HOLDOVER

Revised

OAKSTONE SUBDIVISION

APPLICATION NUMBER Holdover DATE May 19, 2005

DETAIL SITE PLAN

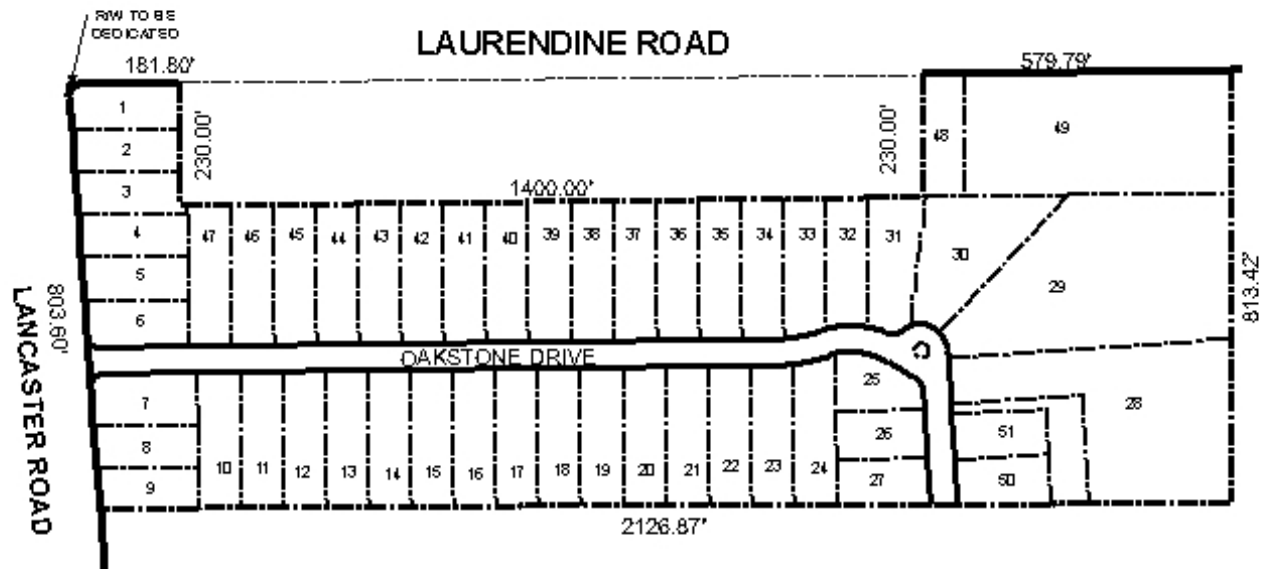
The proposed subdivision will have 11 lots that have direct access to either Lancaster or Laurendine Roads, as well as 40 lots that will only have access to the proposed Oakstone Drive. Oakstone Drive, revised to provide a street stub to the south, is approximately 1,600 feet long to the first turn-around location. Due to the extreme length of the proposed street, the applicant

should provide traffic calming devices in the vicinity of lots 42/43 and 22/35 in order to reduce traffic speeds on the street.

If the calming devices utilized are landscaped traffic islands, these islands, as well as the island provided in the vicinity of lots 25, 29 and 30, should be labeled as common areas, and a note should be placed on the final plat stating that maintenance of the common areas is the responsibility of the subdivision's property owners.

The revised plat shows a relocated detention pond, which appears to be located within the 500-year floodplain, but outside of the 100-year floodplain. The plat has also been revised to show access to the detention pond, in conformance with Sections VI.C.3. and VII.B.2. The applicant should consult with the Mobile County Engineering Department to confirm the appropriate location of the proposed detention pond. Additionally, a note should be placed on the final plat stating that maintenance of the detention basin common area is the responsibility of the subdivision's property owners.

Finally, the written Legal Description and the drawn plat have errors; the southern boundary of the site's length, "2,126.87 feet," is described in the Legal Description as "21,226.86 feet." The bearing of "N 89d 20m 00s E," located on the northwest corner of the site along Laurendine Road, is missing the length dimension of "208.41 feet" that is provided in the Legal Description.

Based upon the proceeding, the revised plat is recommended for Tentative Approval, subject to the following conditions: 1) placement of a note on the final plat stating that traffic calming devices are to be provided, as approved by the Mobile County Engineering Department, in the vicinity of lots 42/43 and 22/35; 2) placement of a note on the final plat stating that the maintenance of common areas and the detention pond is the responsibility of the subdivision's property owners; 3) the dedication of an additional 10-feet along the site's Laurendine Road frontage; 4) placement of a note on the final plat stating that Lot 1 is restricted to access only onto Lancaster Road, that lot 48 is permitted one curb cut onto Laurendine Road, and that lot 49 is limited to a maximum of two curb cuts, with the size, location and design of all proposed curb cuts to be approved by the Mobile County Engineering Department; 5) correction of all written and depicted dimensions and bearings in the Legal Description and on the plat; 6) depiction of the 25-foot minimum building setback line from the dedicated rights-of-way; 7) placement of a note on the final plat stating that any lots which are developed commercially and adjoin residentially developed property must provide a buffer, in compliance with Section V.A.7. of the Subdivision Regulations; 8) dedication and construction of roads to Mobile County standards; and 9) approval of all applicable federal, state and local agencies would be required prior to the issuance of any permits.
